Project Manager Sydney Park Junction 71-79 Pyrmont Bridge Road, PYRMONT NSW 2009

29th September 2021

RE: Sydney Park Junction

Figure 1: Plan showing the proposed changes to Sydney Park Road, King Street and Princes Highway (Source: Transport for NSW)

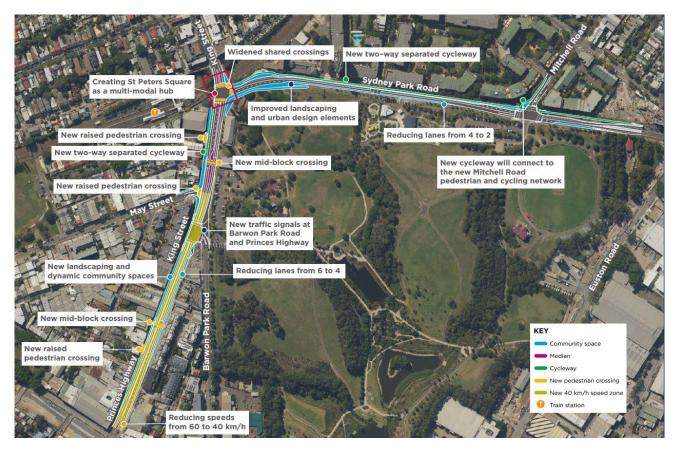
Dramatically improved pedestrian amenity, safe crossing points, new tree canopy, reduced noise and pollution and lowered speeds will attract people to stay and play. The plan in Figure 1 summarises the proposed changes.
